**Technical Memorandum**  
**Arroyo del Puerto Embankment/Channel**  
**Additional Information, Revision 1**

<b>To:</b>	Thomas McLaughlin	<b>From:</b>	 John M. McBee, P.E.
<b>Company:</b>	Nuclear Regulatory Commission	<b>Date:</b>	May 21, 2008
<b>Re:</b>	Arroyo del Puerto Embankment/Channel Additional Information	<b>Project #:</b>	1155690067
<b>CC:</b>	Terry Fletcher, Rio Algom Mining LLC

CONSTRUCTION STATIONING & RIPRAP PLACEMENT  
 ARROYO DEL PUERTO  
 DIVERSION EMBANKMENT/CHANNEL  
 AMBROSIA LAKE MILL  
 RIO ALGOM MINING LLC  
 GRANTS, NEW MEXICO

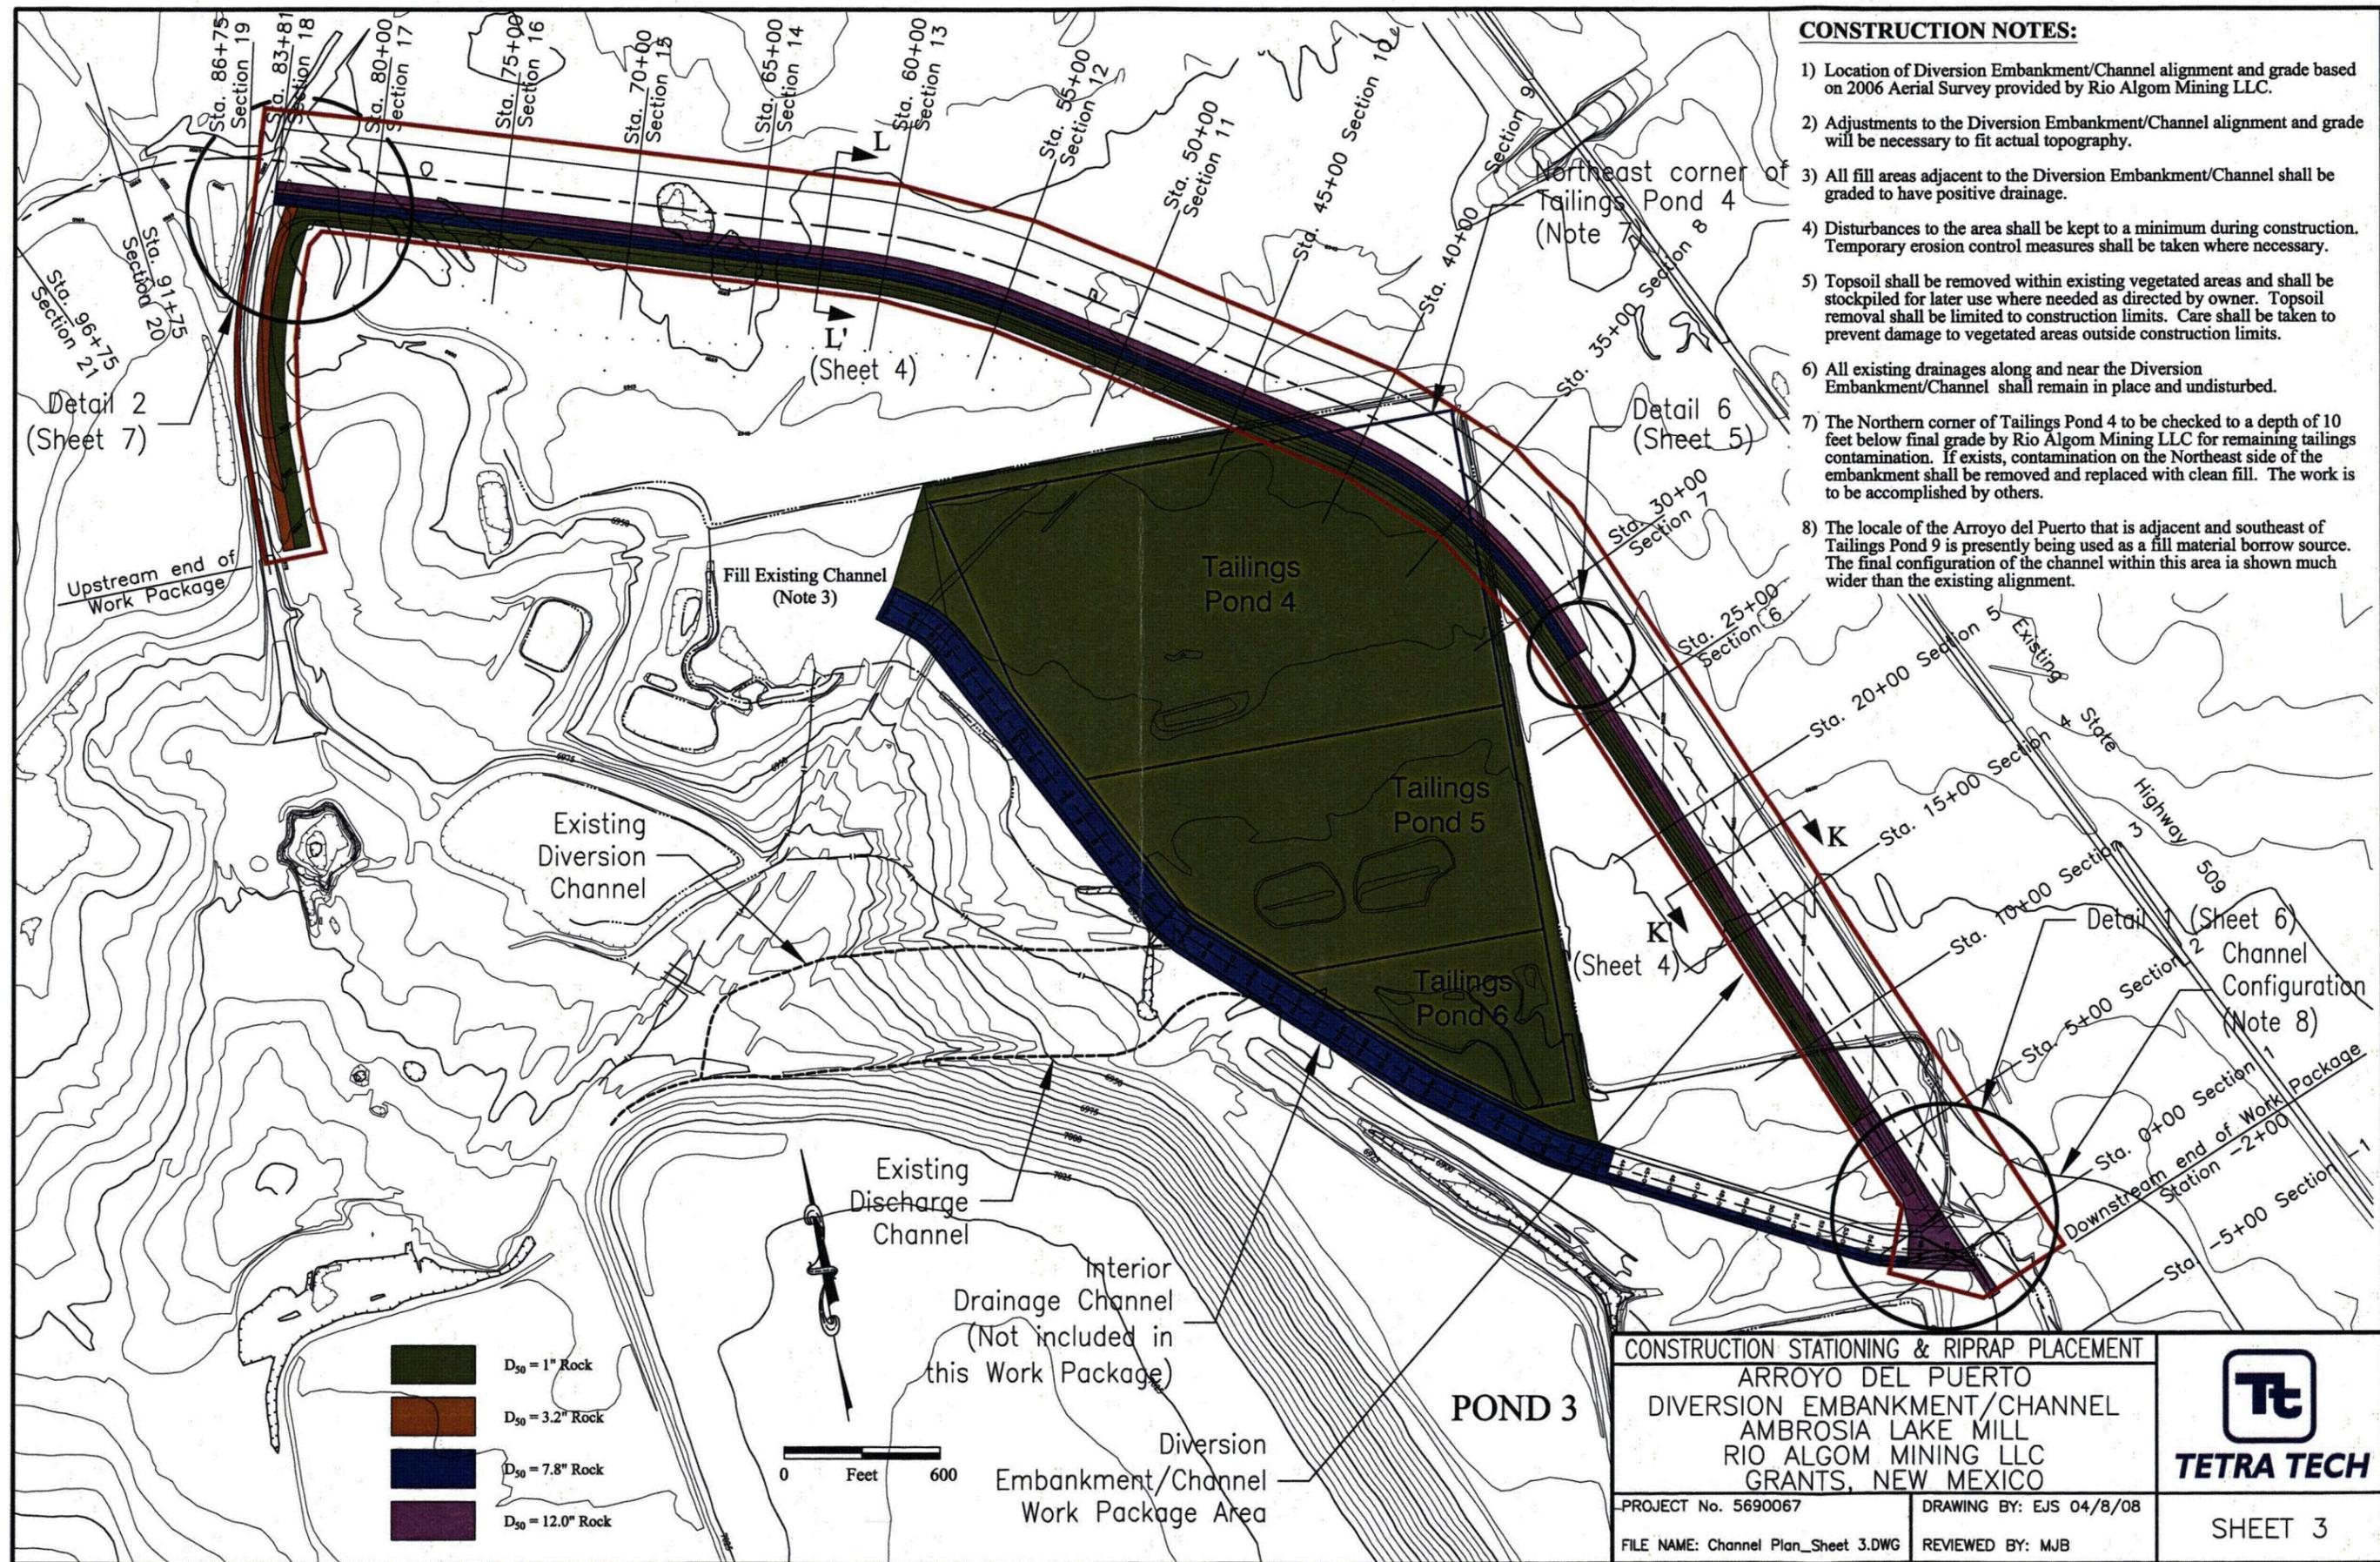
Potential Concern 2: The largest possible footprints of Ponds 4, 5, and 6 are shown in the construction drawings (Sheet 3 attached). Prior to design of the diversion channel in the vicinity of the northeast corner of Pond 4, aerial photographs of the facility taken during milling operations were reviewed to assess the actual limit of tailings ponding in the Pond 4. No ponding of tailings effluent was seen in any of the aerial photos in the extreme northeast portion of Pond 4. The height of the berms used to construct Ponds 4, 5, and 6, were approximately four feet and based on the slope of the topography, ponding over the entire footprint shown would have required a higher embankment.

In the northeast portion of the area shown as Pond 4 (an approximate 2-acre area – see Sheet 3, attached) that will be in the diversion channel, soils were sampled to the calculated potential scour depth to either: 1) confirm that no impacted subsurface soils were present; or 2) locate potentially impacted soils that would require excavation and relocation to the Pond 2 disposal cell. The results of the soil samples from 10 borings did not indicate tailings ponding in this area. Sample analyses included radium-226, uranium, or thorium-230 and only one soil sample (taken at 0' to 2') had an elevated reading (55 pCi/g for thorium-230) above the soil cleanup standards (14 pCi/g for thorium) per the *Soil Decommissioning Plan* (Komex, 2006). This area was re-sampled with soil samples taken from 0' to 1' (on 6" increments) at three locations approximately 10' away from the boring. Results of all six samples, which ranged from 0.3 to 1.8 pCi/g, were well below the cleanup standards for thorium-230, so no further action was warranted.

The interior channel will be constructed adjacent to the southwest sides of Ponds 4, 5, and 6 and will not be excavated into potentially impounded areas of the former ponds. The side rock apron of the channel will tie to the erosion protection rock to be placed over the entire conservatively estimated footprints of Ponds 4, 5, and 6. The alignment of the original Arroyo del Puerto will be straightened by construction of the interior channel and the channel will be lined with erosion protection rock to prevent scour from a probable maximum flood (PMF) event.
